GE Energy

MFN 06-135

Docket No. 52-010

**Subject: Partial Response to RAI Letter Numbers 20 and 27 Related to ESBWR Design Certification Application – Seismic Design – DCD Sections 2.5 and 3.7 – RAI Numbers 2.5-2 through 2.5-7; 3.7-1 through 3.7-4, 3.7-6, 3.7-9, 3.7-10, 3.7-13 through 3.7-15, 3.7-17 through 3.7-23, 3.7-28, 3.7-31, 3.7-36, 3.7-40 through 3.7-49, 3.7-51, 3.7-53, and 3.7-56**

Figure 3.7-9 (1) Normalized Cumulative Energy for Horizontal (NS) Design Time History

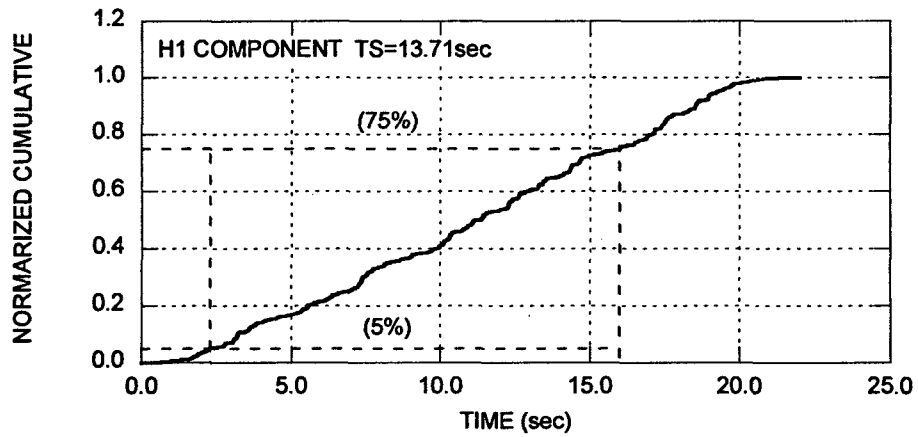
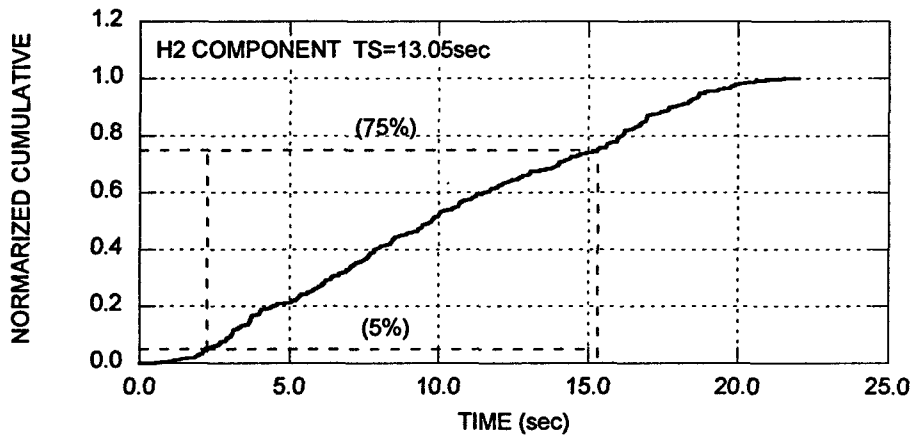
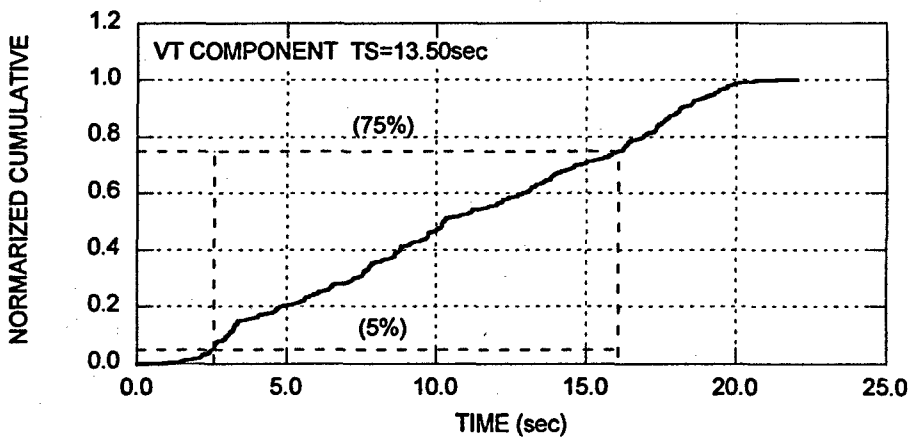
*In DCD Section 3.7.1.1.2, the applicant indicated that the total duration of the artificial time histories used to envelop the RG 1.60 spectra is 22 seconds. In addition, the applicant indicated that the response spectra computed from the synthetic time histories are computed at the additional frequencies of 40, 50 and 100 Hz. This sparse frequency set above 33 Hz is not considered adequate to judge the appropriateness of the time history fit between 33 and 100 Hz. To assist the staff in its review, the applicant is requested to provide the following additional information:*

The normalized cumulative energy plots are shown in Figure 3.7-9 (1) through (3).

Figure 3.7-48 (1) Passive Soil pressure for Energy Components of Embedment

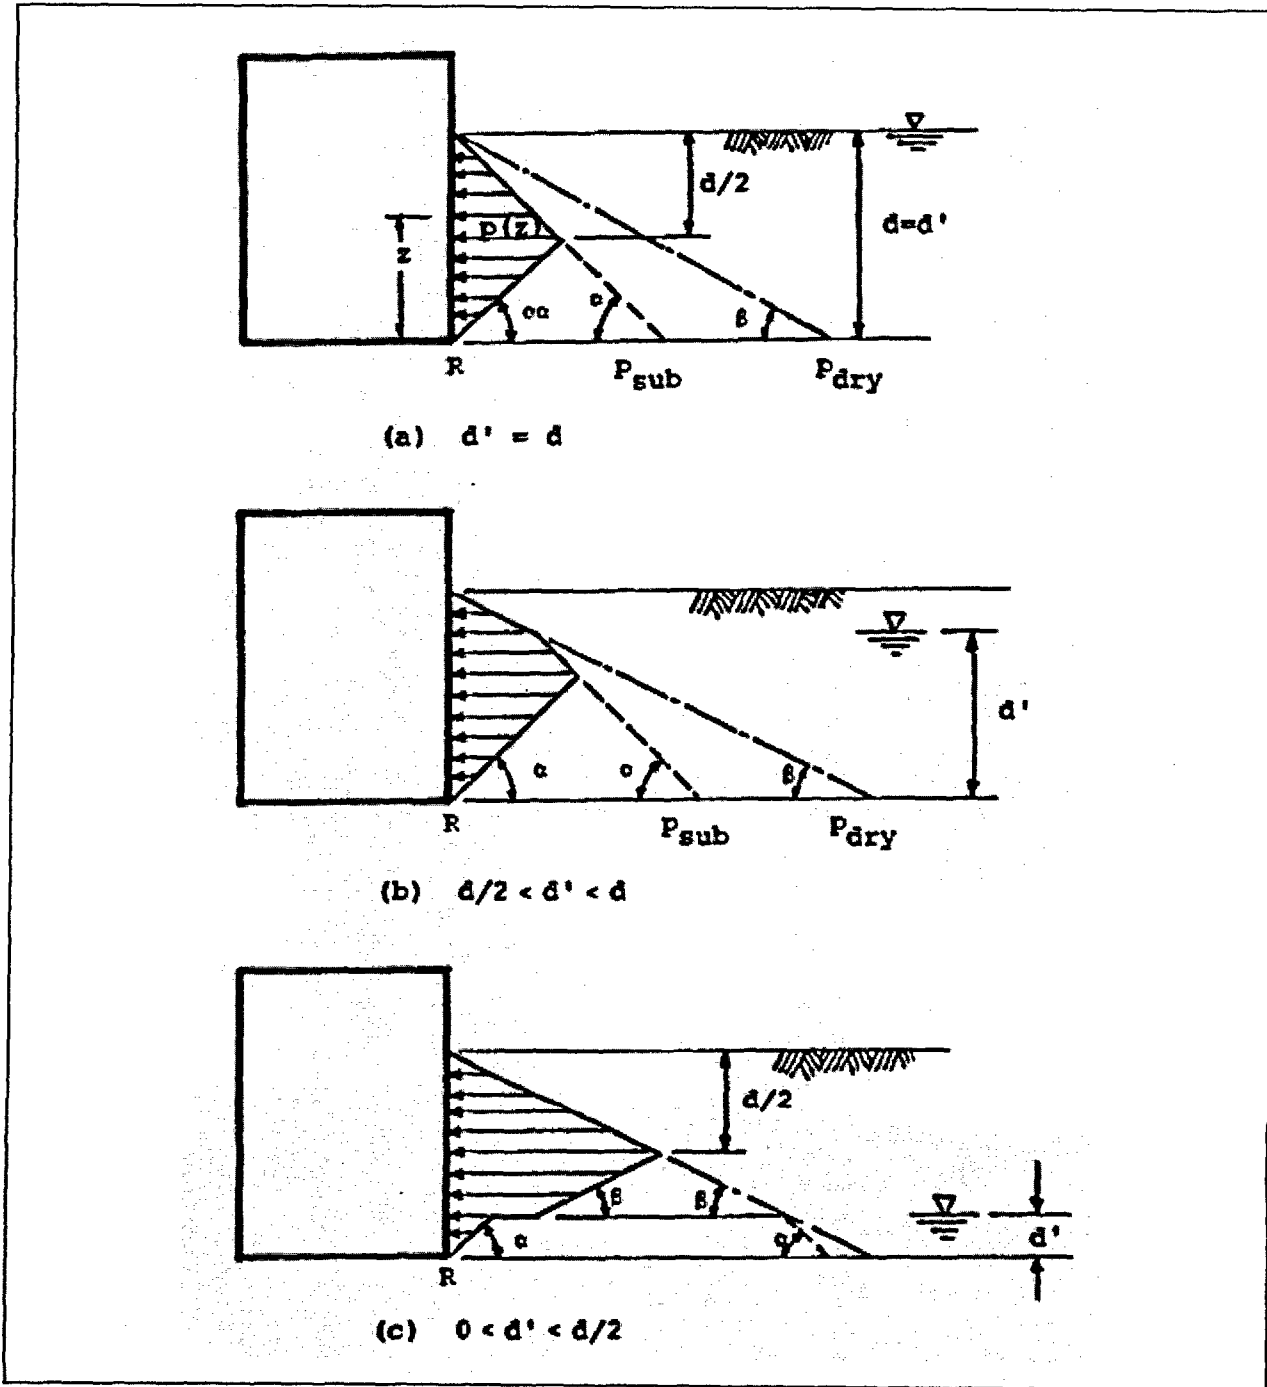
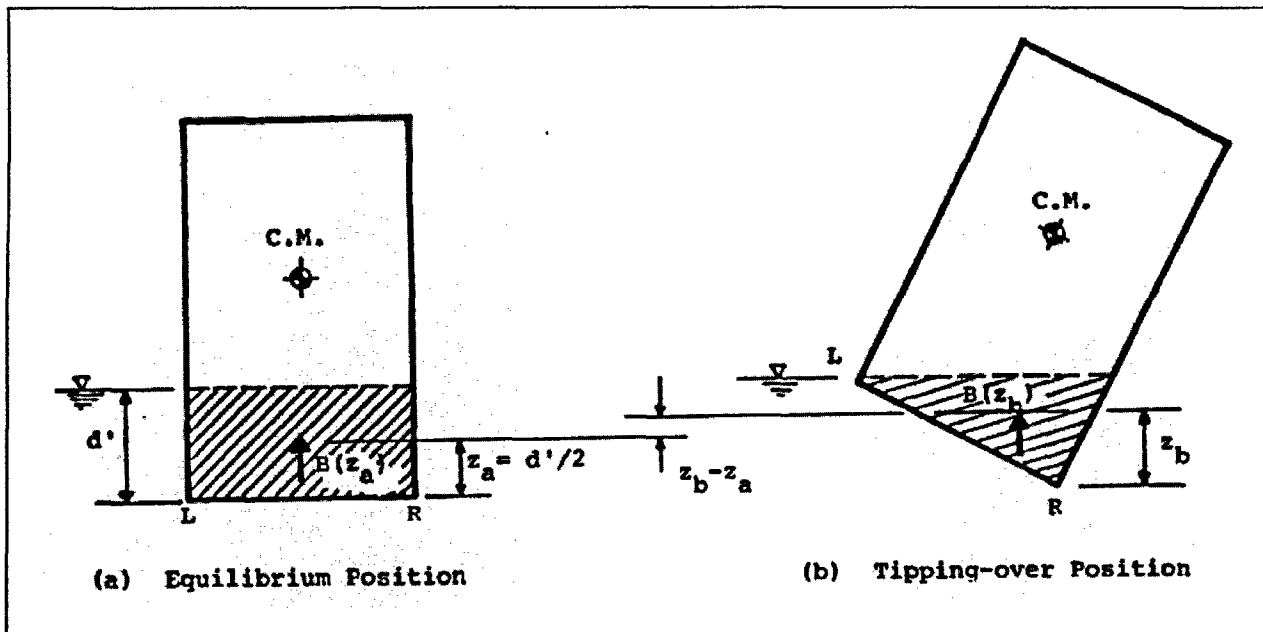
*In DCD Section 3.7.2.14, the applicant described the use of an energy method to evaluate the stability of structures against seismically induced overturning moments. The applicant is requested to provide a more detailed description of the analysis method, including an explanation of how the energy components for the embedment ( $W_p$ ) and buoyancy ( $W_b$ ) are determined, and the technical justification for the two equations given for the velocity terms ( $V_h$  and  $V_v$ ).*

Energy components for the embedment ( $W_p$ ) is illustrated in Figure 3.7-48 (1).

Energy components for the buoyancy ( $W_b$ ) is illustrated in Figure 3.7-48 (2).

The reason for the use of the two equations given for the velocity terms ( $V_h$  and  $V_v$ ) is that the two expressions in DCD Equation 3.7-21 are the SRSS method of combination to obtain the maximum value of total velocity response in view of non-simultaneous occurrence of the peak values of ground velocity and relative velocity response.

**Figure 3.7-49 (1) Approximate Method of Soil Spring**

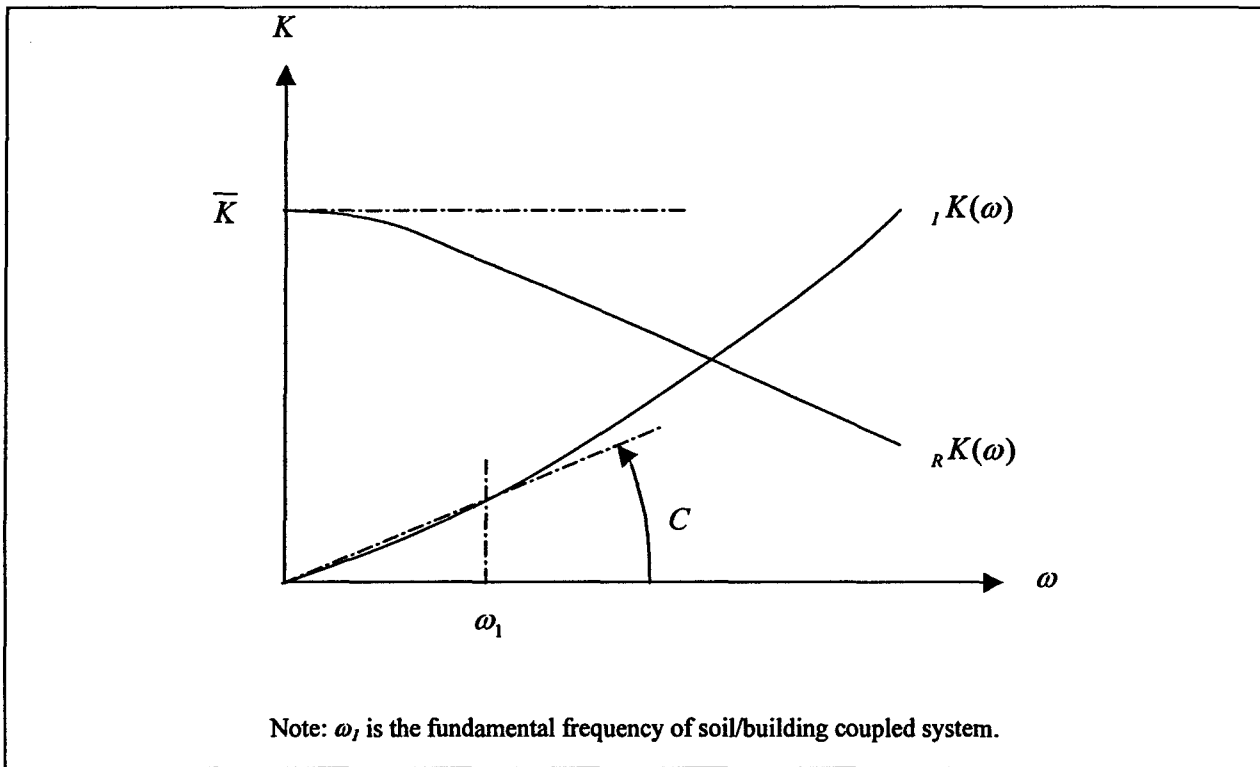
*The applicant is requested to provide the following information needed for the staff to perform its confirmatory analyses:*

As shown in Figure 3.7-49(1), the base spring value derived from the vibration admittance theory is a function of frequency  $\omega$ , and can be represented by complex stiffness  ${}_R K(\omega) + i{}_I K(\omega)$  (where  ${}_R K$  is the real number portion, and  ${}_I K$  is the imaginary portion). However, since the expression  $({}_R K(\omega) + i{}_I K(\omega))$  is complicated to be used directly in response analysis, the spring values are simplified and replaced with frequency independent soil spring and damping coefficient, respectively, for the time history analysis solved in time domain. The approximate method is described below.
